**Stage 1/2 Road Safety Audit
Proposed Residential Development
Gort Mhaoilir, Athenry, Co. Galway**

Client:	Galway County Council
Document No:	242462-ORS-XX-XX-RP-TR-13g-002

Problem No.02: Tie-in to Existing Footpath

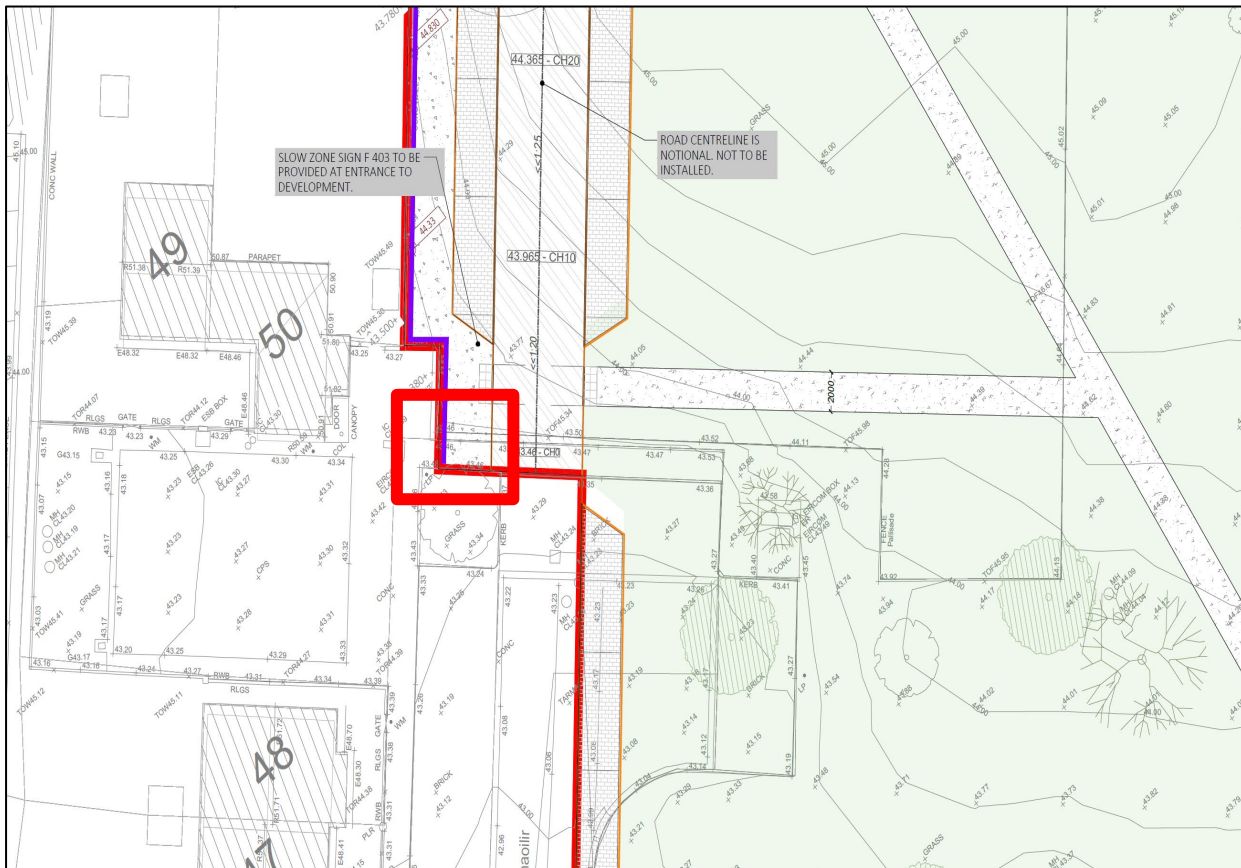
The audit team note from the site visit and drawings and the site visit that the existing footpath is narrower than the proposed at the intended tie in location. It is not clear how the existing and proposed footpaths are to tie in with each other. Lack of an appropriate tie-in to the existing footpath could lead to pedestrian trips and falls.

The design team should provide provision for appropriate tie-in and width to the existing footpaths.

Problem No.03: Sightline Availability

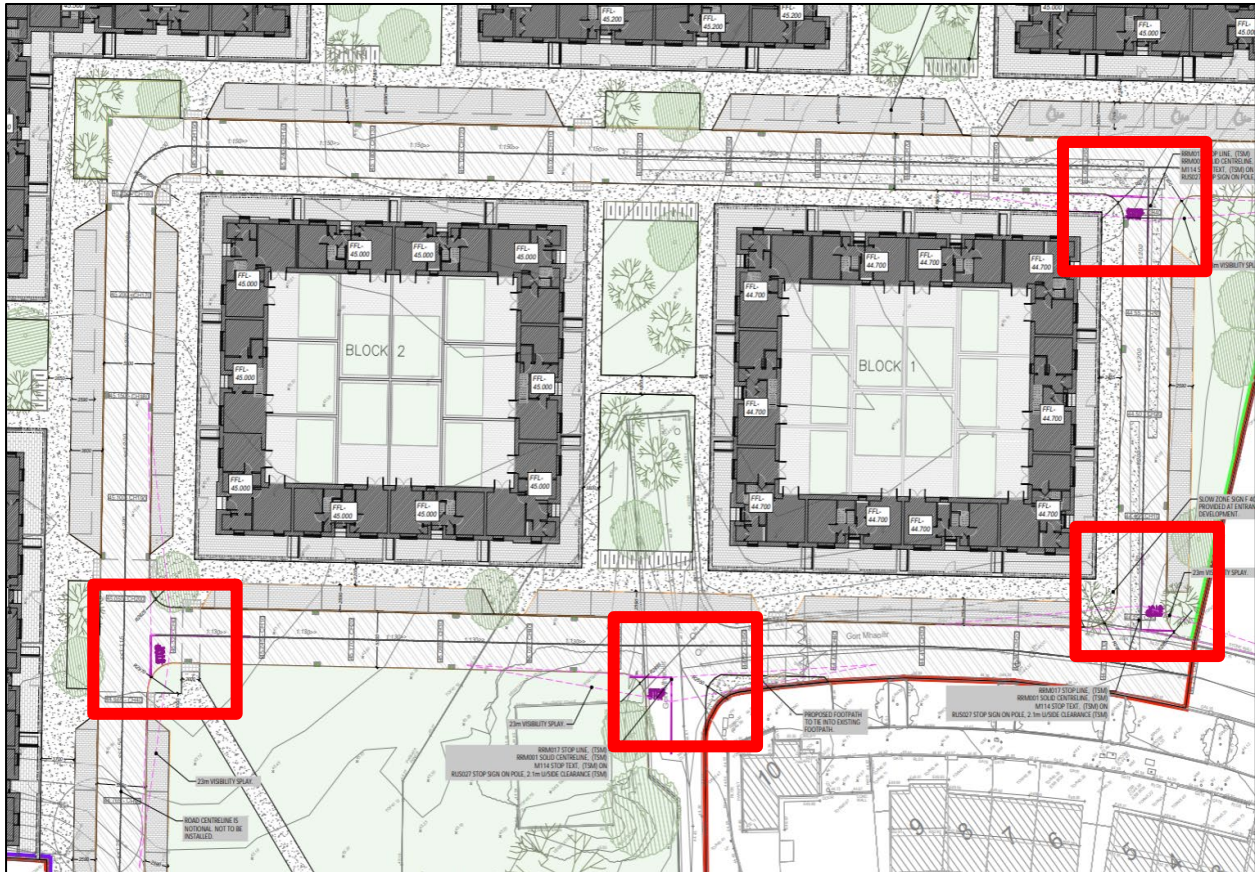
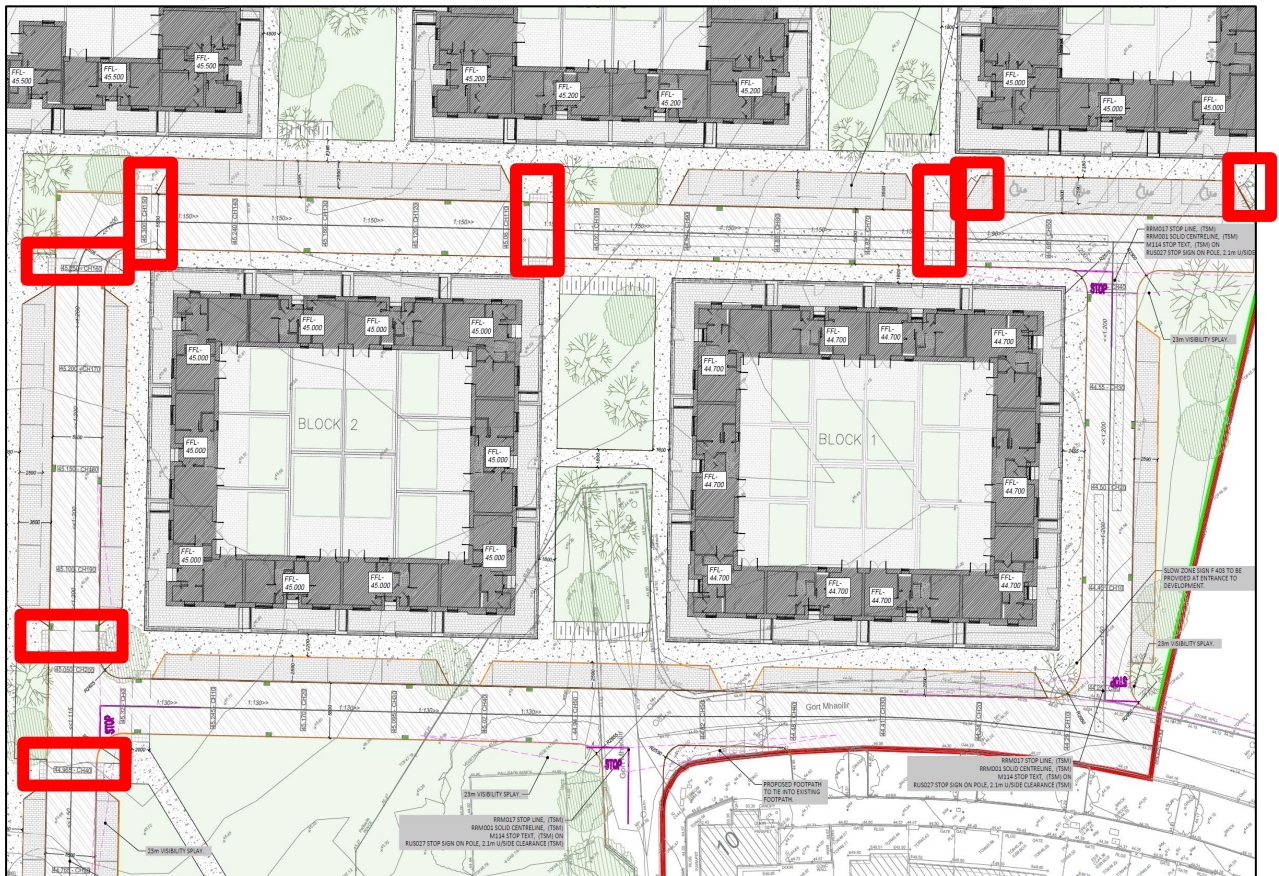
The audit team note that there are no sightlines in the drawings provided to demonstrate that appropriate sightlines can be achieved when vehicles are entering and exiting the development. The audit team is concerned that the appropriate sightlines cannot be achieved as boundary walls, landscaping and parked cars along the carriageway may obstruct visibility at the junctions. This could result in vehicles encroaching onto the main carriageway into the line of oncoming vehicles which could lead to sideswipe or side impact type collisions.

The design team should ensure that clear visibility is provided in both directions and that visibility envelopes are clear of any obstacles.

Problem No.05: Pedestrian Visibility at Uncontrolled Crossings

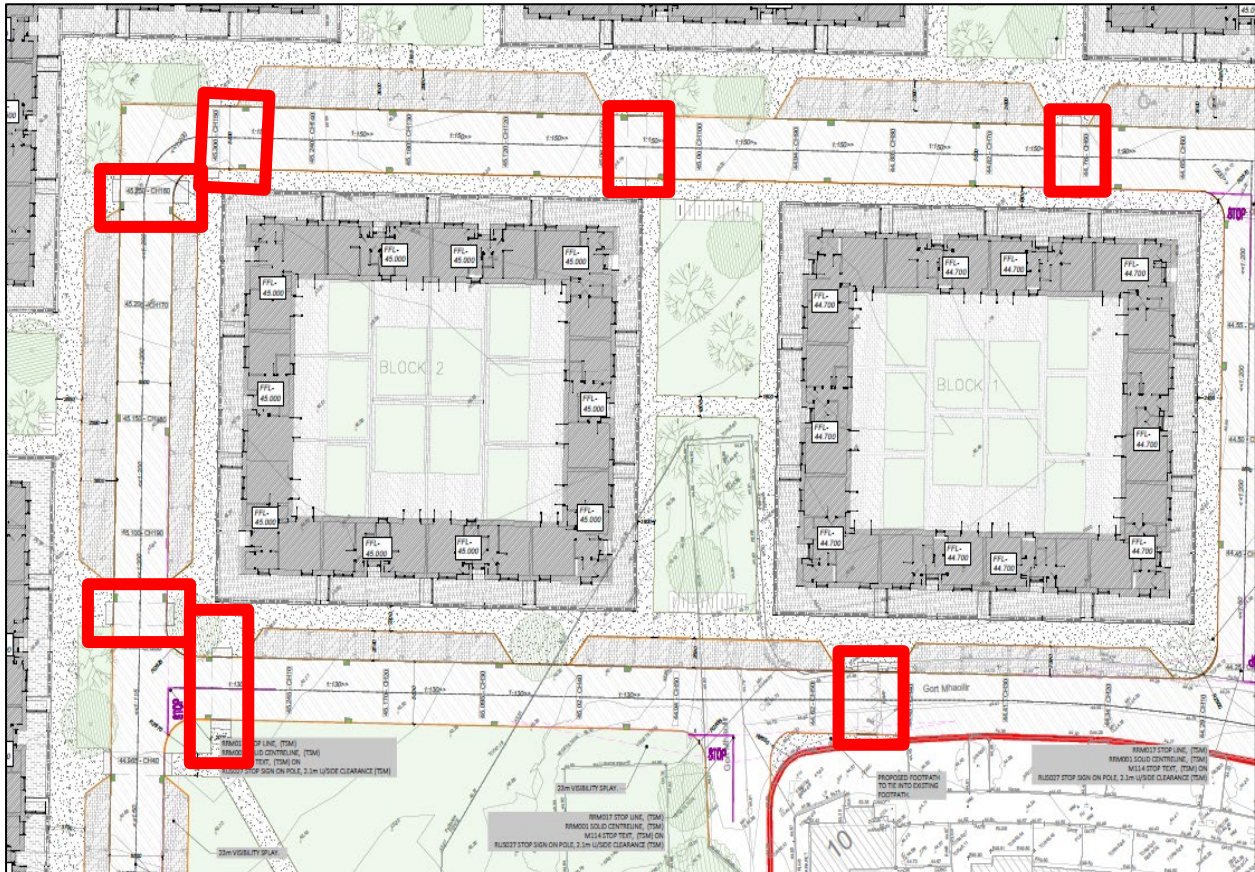
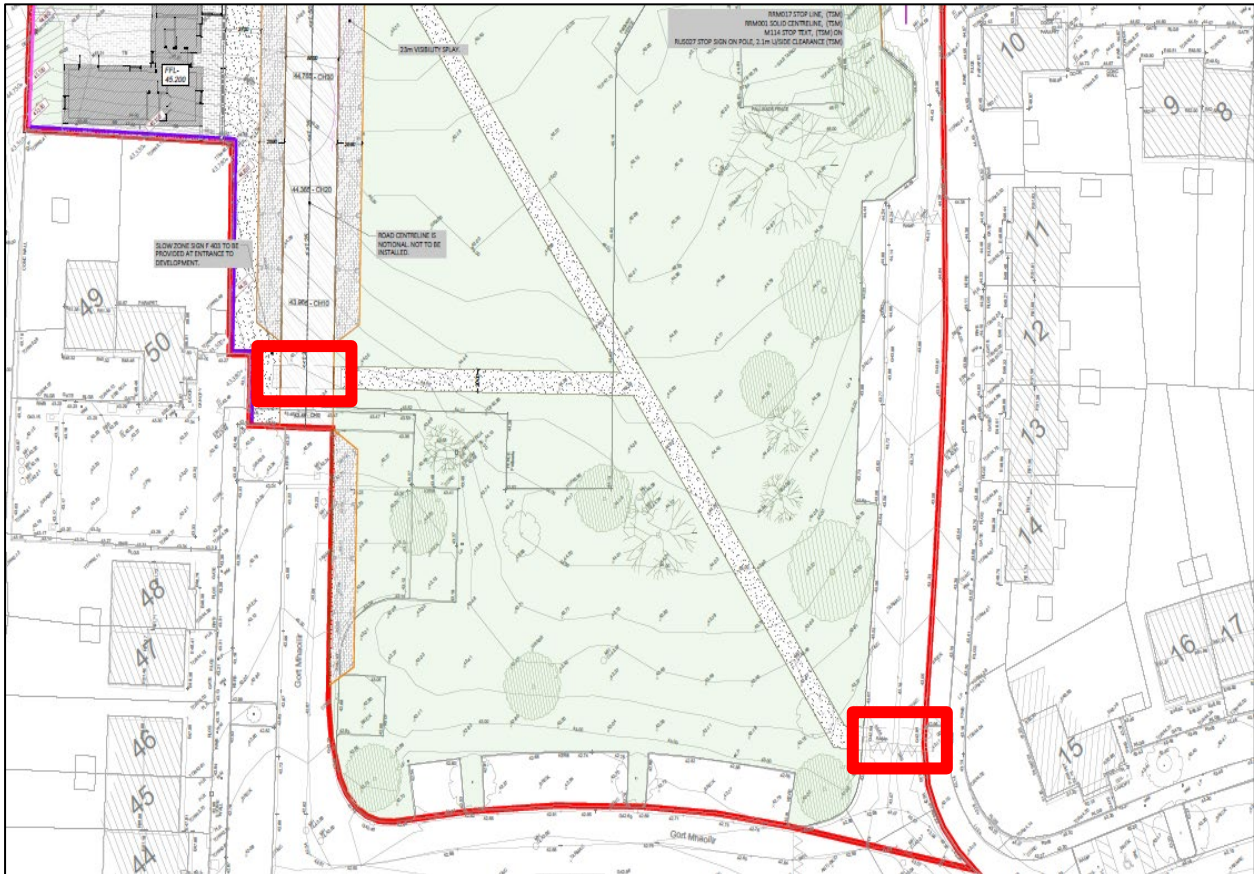
The audit team note that the proposed drawing does not detail the visibility from the uncontrolled crossing at the locations identified. It is not clear from the drawings if appropriate visibility is provided for at the crossings. The audit team is concerned that parked vehicles and vegetation may restrict visibility for both pedestrians and vehicles approaching the crossings which could lead to conflicts between pedestrians crossing and vehicles on the internal road.

The design team should provide pedestrian visibility splays and forward visibility splays along the internal road to ensure visibility is not obstructed by any permanent features.

Problem No.06: Inappropriately Located Gullies

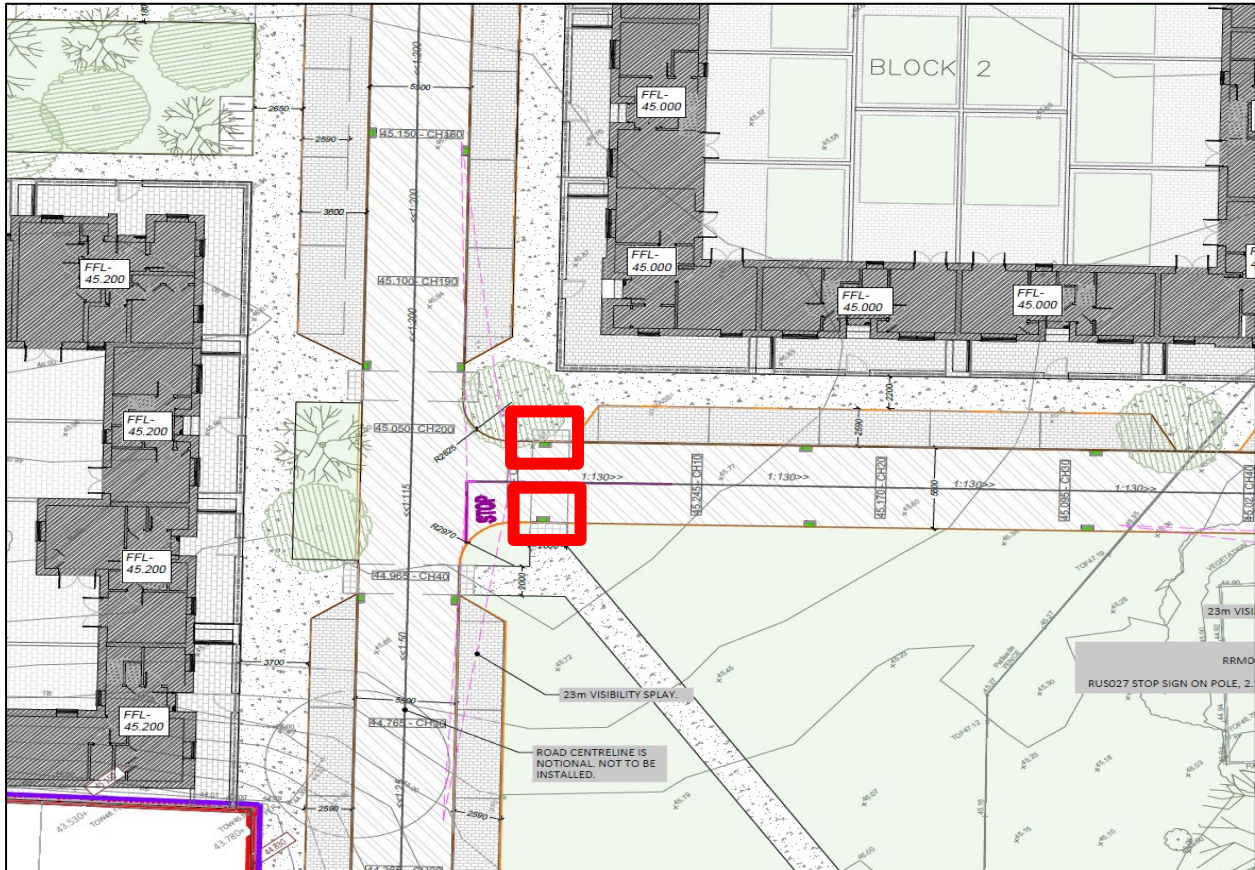
The audit team note from the drawings provided, that there are gullies located within areas designated for vulnerable road users at the locations identified. Inappropriate gully positioning may lead to potential trip and fall hazards for vulnerable users.

The design team should ensure drainage gullies are strategically positioned outside of pedestrian crossings.

Problem No.08: Speed Control Measures and Road Widths

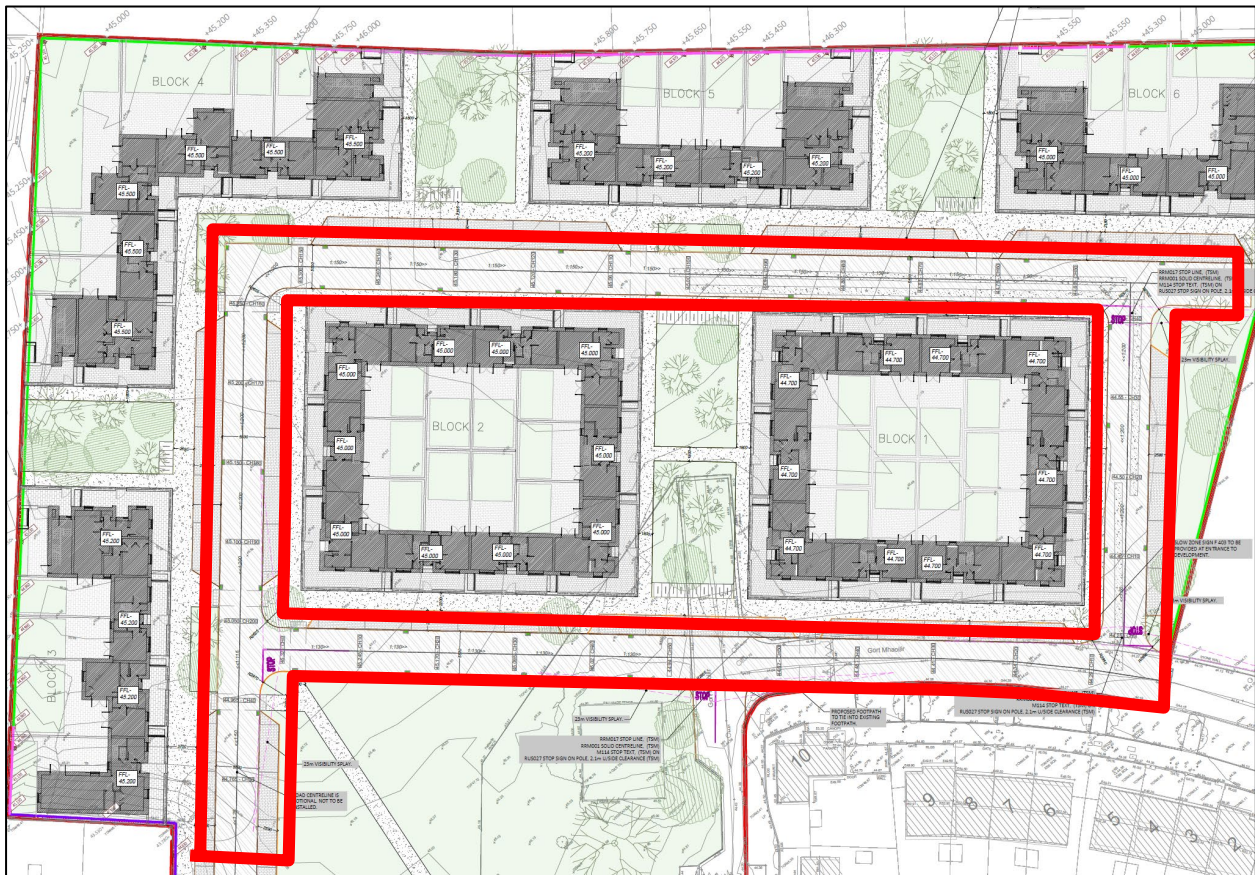
The audit team noted from the drawings provided, that there are no speed control measures proposed throughout the scheme. The audit team are concerned that the layout as its currently presented particularly with the long straight stretches could encourage higher speeds which could put vulnerable users within the development at risk of serious injury.

The design team should ensure that appropriate speed control measures are incorporated within the development to reduced vehicular speeds.

Problem No.09: Desire Line

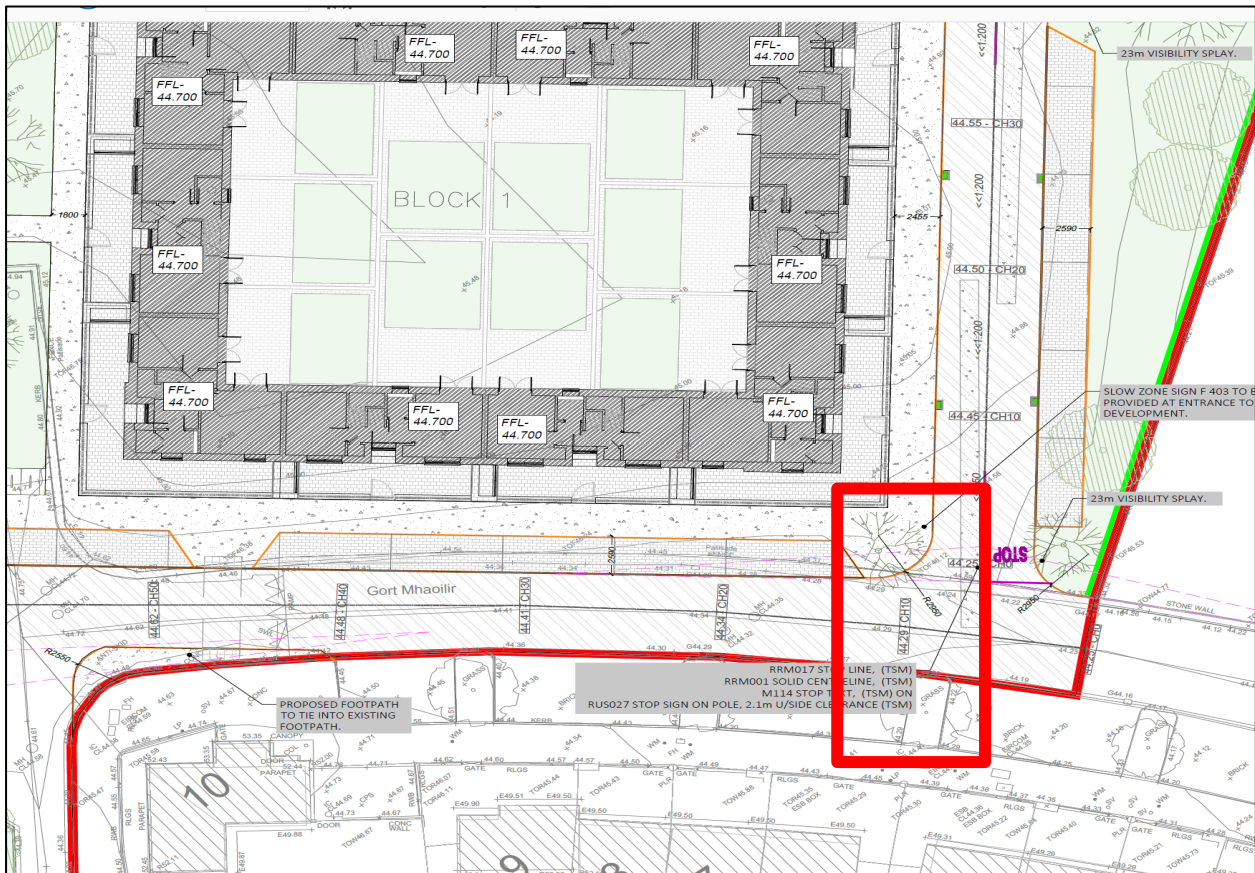
The audit team note from the provided drawings that there is no crossing points proposed on the pedestrian desire line. The audit team has concern's that pedestrians will cross on the desire line for which there is no pedestrian facilities for on both sides of the road. This could lead to slips and trips leading to injury of pedestrians.

The design team should ensure that crossing points are provided along desire lines.

Problem No.10: Location of Uncontrolled Crossing

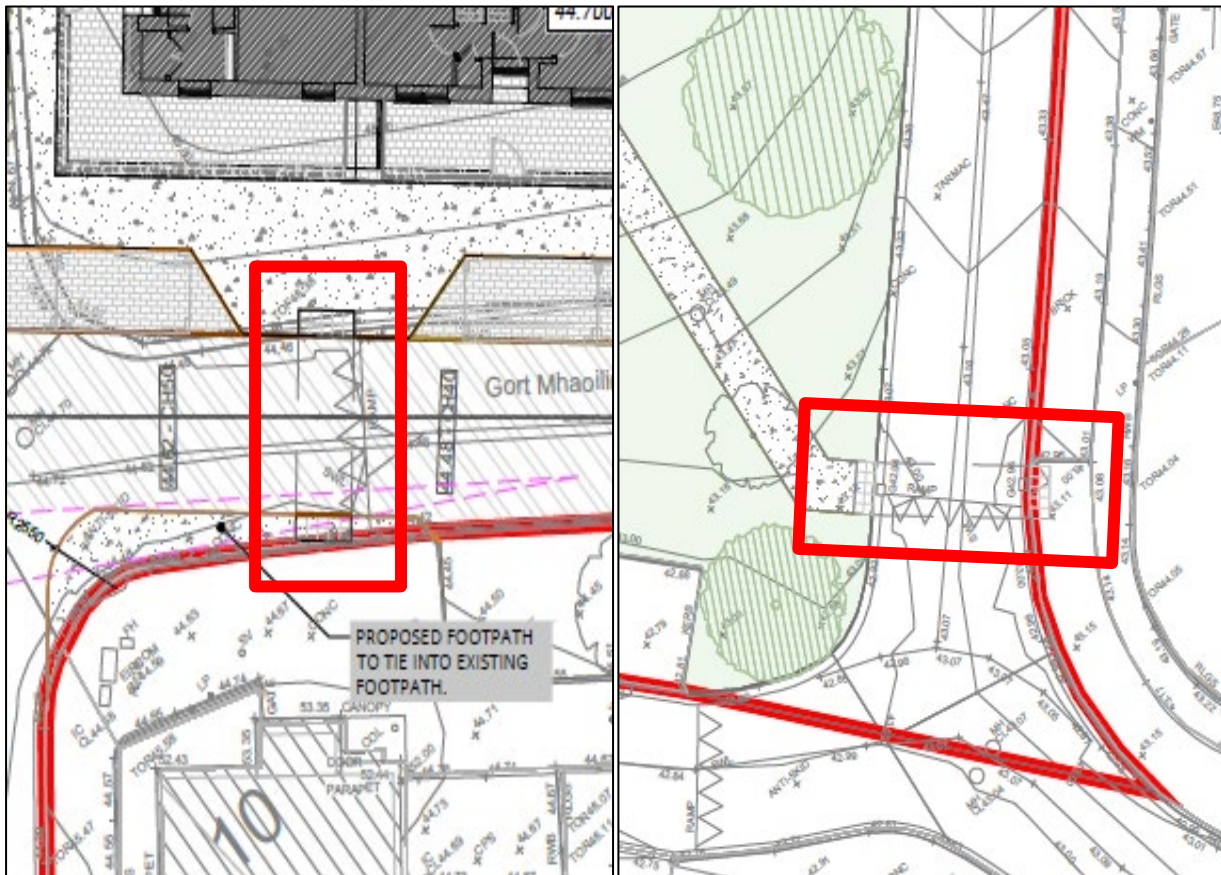
The audit team note from the drawings provided that the proposed uncontrolled crossings appear to be on the sloped section of the raised table. The position of the crossings leads to an uneven surface particularly for mobility impaired pedestrians which could result in slips, trips and falls at the crossing location which could lead to injury.

The design team should provide the uncontrolled crossings in the appropriate position on the raised table.
